Norfolk Gliding Club Ltd

Norwich to Tilbury EN020027

Response to REP2-029

Aerodrome Impact Assessment Summary – Runways

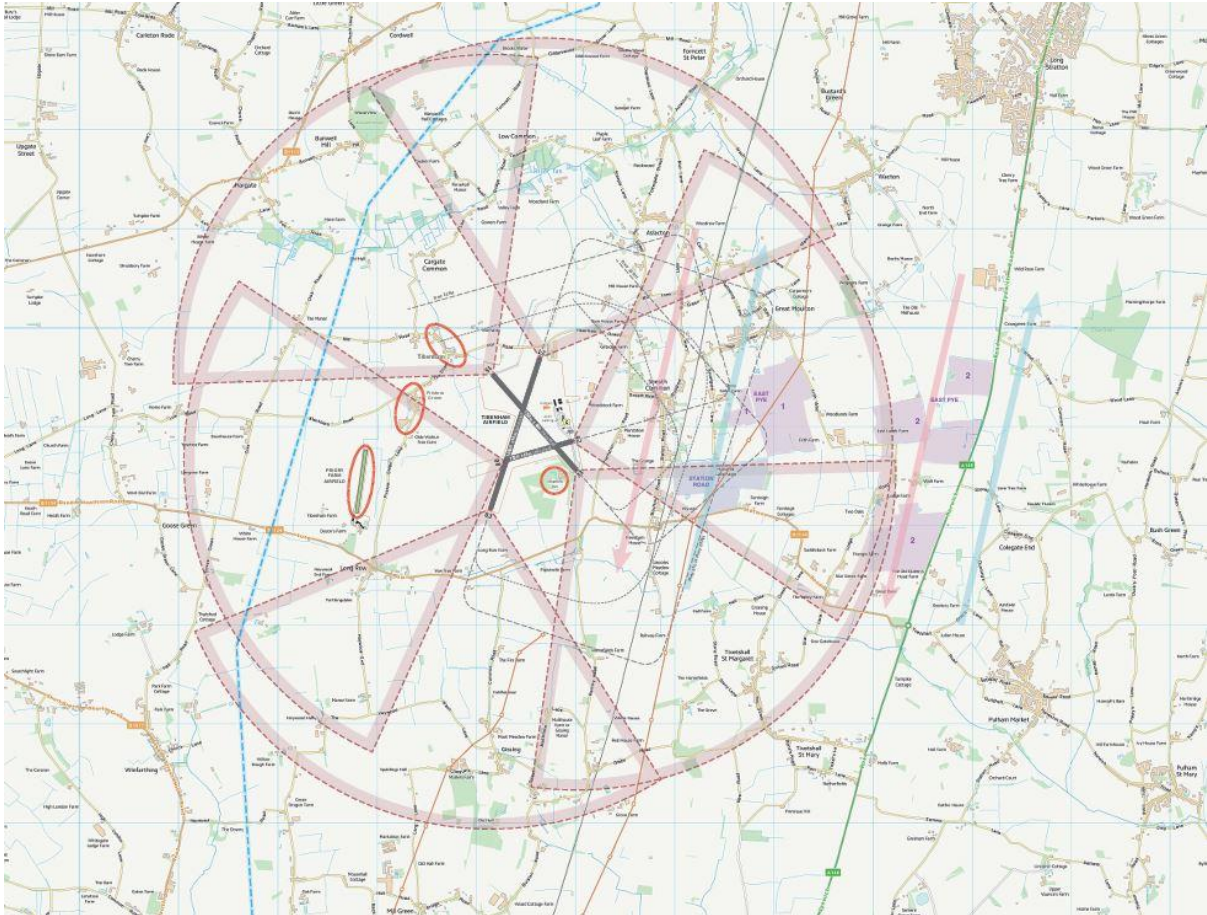
Under the heading OHL in Splay from runway 26 pylons RG56 – 59 are identified. The applicants accompanying drawings 01_220101_97 Rev A, and 01_220101_91 Rev A show the splay to be in the order of +/- 5° either side of the extended centreline.

CAA guidelines state that the splay should be +/- 30° and that greater margins should exist where the airfield is used for flight training such as at Tibenham. Why are these values not being used?
